E-34447  
January 18, 2013

Subject: ASME Code Alternative Request  
Docket No. 72-1027

## **Request for Alternative to ASME Code Rule for TN-68**

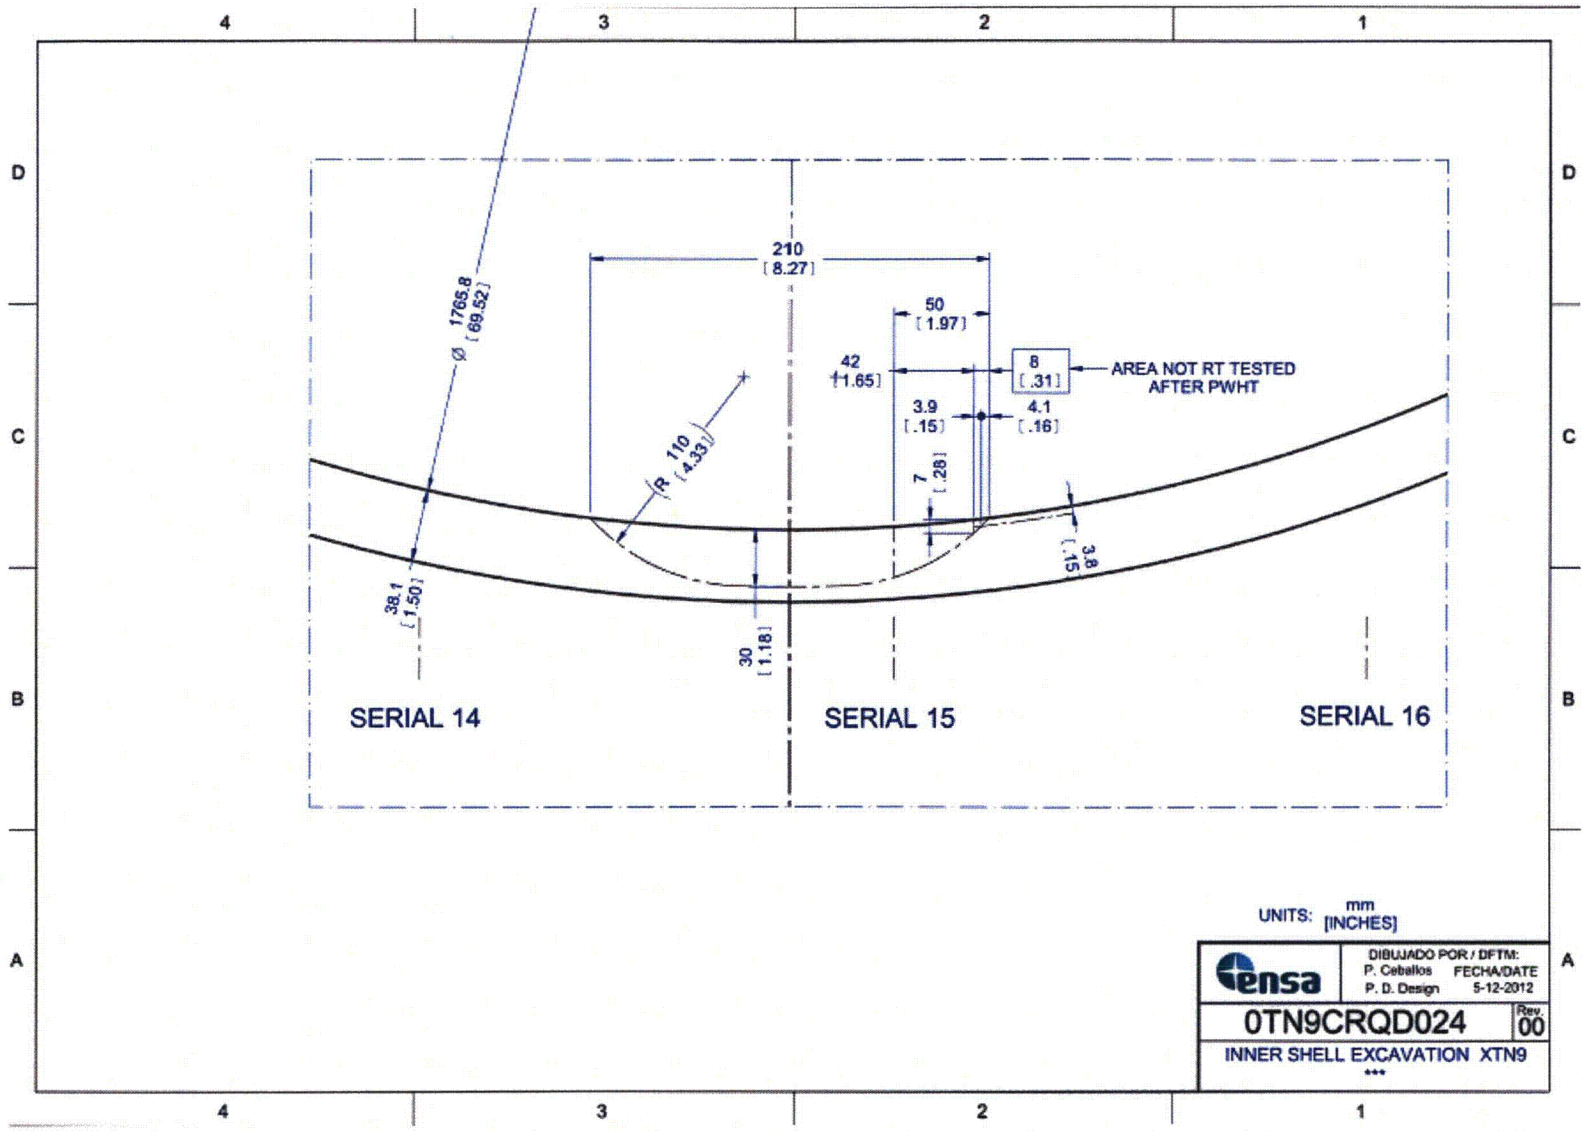
A 220 mm (8.66 in.) diameter grinding disc was used to remove the defects in the weld seams. To reach the depth of the defects in Zone 14-15, it was also necessary to remove material from Zone 15-16. Thus, the grinding in Zone 14-15 extended by 50 mm (1.97 in.) into Zone 15-16. Note that Zone 15-16 was defect-free. Refer to Attachment 3 for description of excavation.

The pre-PWHT RT film for Zone 14-15 was found to cover 75 mm (2.95 in.) into Zone 15-16. However, the post-PWHT RT film in Zone 14-15 was found to cover only 42 mm (1.65 in.) into Zone 15-16. Therefore, entire weld repair was radiographed before and after PWHT except for the outer 8 mm (50mm – 42mm = 8mm) (0.32 in.), which was not radiographed after PWHT.
